GROUP	MODEL
ELE	2025MY EV9 (MV1a)
NUMBER	DATE
392 (Rev 1, 03/06/2026)	August 2025

## TECHNICAL SERVICE BULLETIN

### BSA REPLACEMENT GUIDANCE

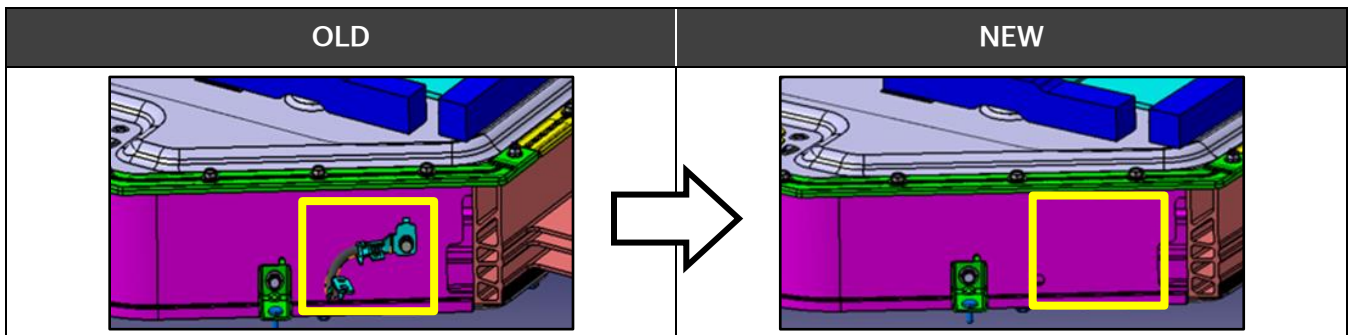
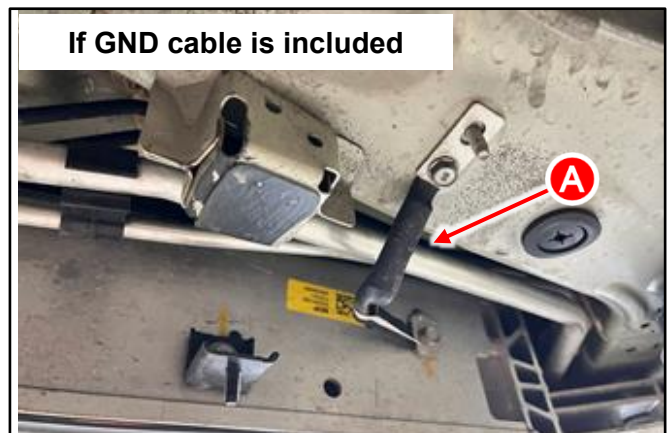
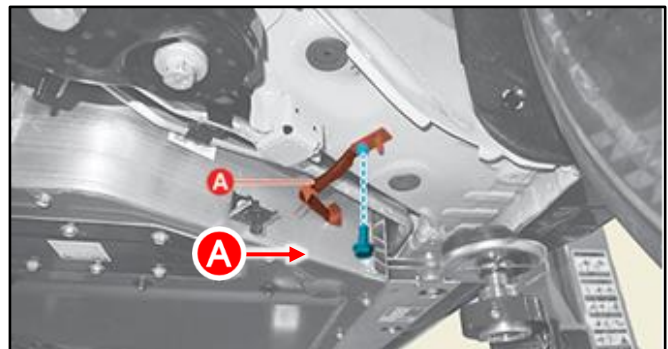
- The 'Front Under Cover Assy' are interchangeable between MV1 and MV1a (37501-XA250 to 37501-DO050). **However, since the underbody cover hardware differs between models, the underbody cover hardware must be replaced simultaneously when replacing the BSA.**

If you are replacing a high-voltage battery with an identical part number, replacement of the underbody cover fixing hardware is not required.

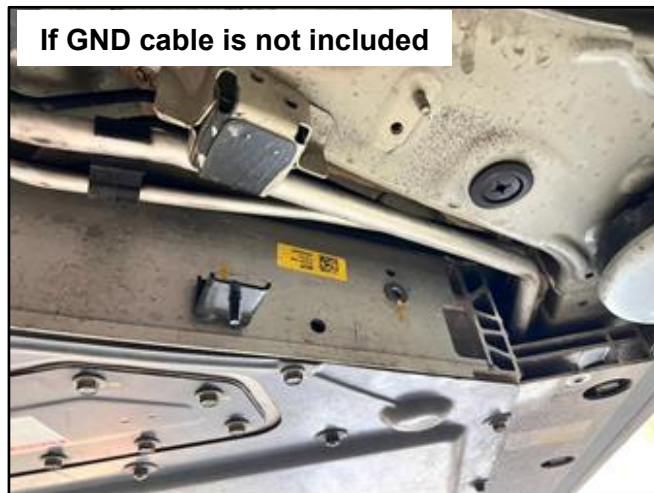
- If the replacement Battery System Assembly (BSA) includes a ground (GND) cable (A), then replace both the BSA and the GND cable** using the newly supplied components, by referring to Battery Control System → High Voltage Battery System → Battery System Assembly (BSA) → Removal and Installation in KGIS.

- If the replacement Battery System Assembly (BSA) does not include a ground (GND) cable, then the GND cable does not need to be installed.

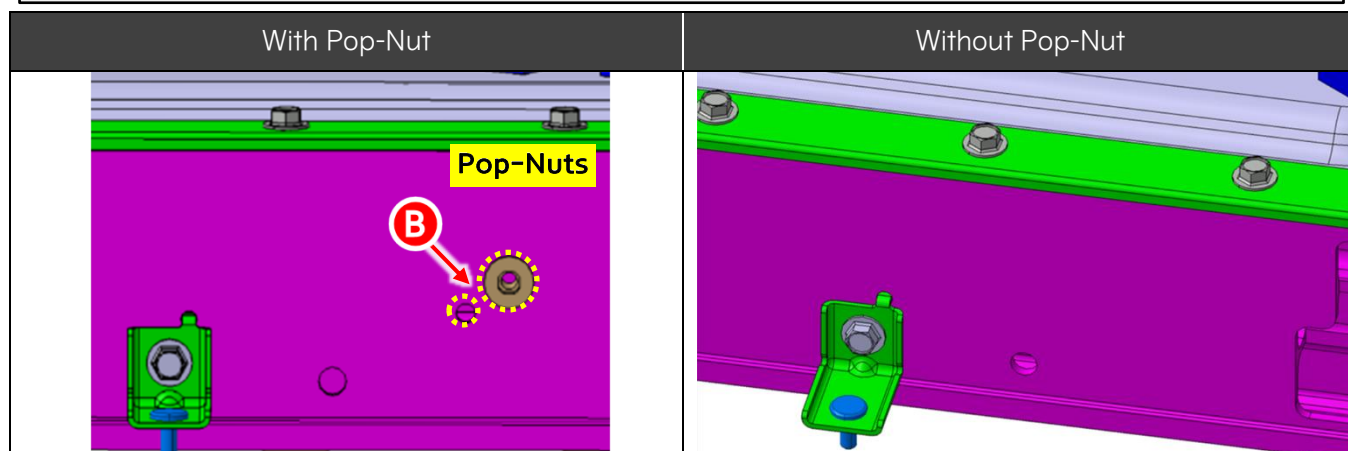
Some Battery System Assemblies (BSA) may feature pop-nuts (B) on the case; however, the presence of pop-nuts does not necessarily indicate that a ground (GND) cable should be installed.
